CITY OF ALBUQUERQUE

**RE: Aloha RV Expansion
8212 Pan American Fwy NE
Grading and Drainage Plan
Engineer's Stamp Date: 2/6/19
Hydrology File: C18D104**

Based on the submittal received on 2/8/19, the Grading and Drainage Plan cannot be approved until the following are corrected:

ALOHA RV
8212 PAN AMERICAN FWY, NE
GRADING PLAN

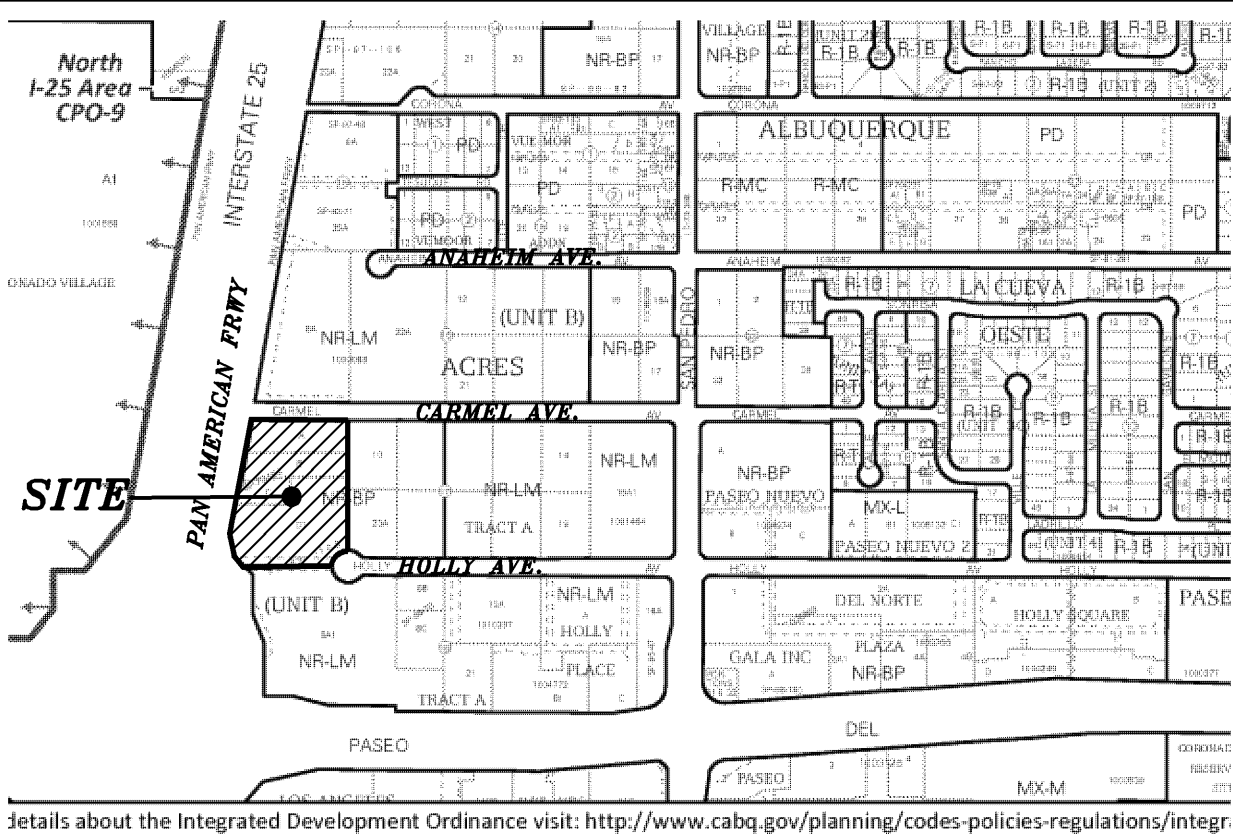
1. Allowable discharge for this area is 3.14cfs/ac (not 3.41), including paved frontage on Holly and Carmel. When determining your site's allowable discharge, be sure to deduct the frontage to the centerline, which free-discharges.

2. Proposed contours need to tie-in at the property line; relook along the west side of your site. The proposed contours also seem to ignore the presence of curbs and pond A seems to encroach on the drive aisle.

3. Delineate and provide the area of new paving; Paving Permit approval likely needs to be requested as well. Show how the areas of new paving will be routed into a storm water quality pond (curbcut and rundown into pond A?).

4. Basins need to be delineated, and the ponds sized for the areas draining to them. Increased discharges or modified discharge points to the NMDOT ROW will require their approval.

5. Pond details are lacking. Pond volume calculations need to determine the surface area and associated volume by each contour. The pond B volume calculation doesn't match the callout on the plan. Provide primary and emergency spillways for the ponds, supported with hydraulic calculations and include freeboard.

7. This project requires an ESC Plan, submitted to the Storm Water Quality Engineer (Curtis Cherne PE, ccherne@cabq.gov or 924-3420).
8. "Calculations" references an AHYMO Model which is not provided.

9. Include project benchmark and datum.
10. Add note on the plan that "No work shall be performed in the public ROW without an approved Work Order or Excavation Permit."
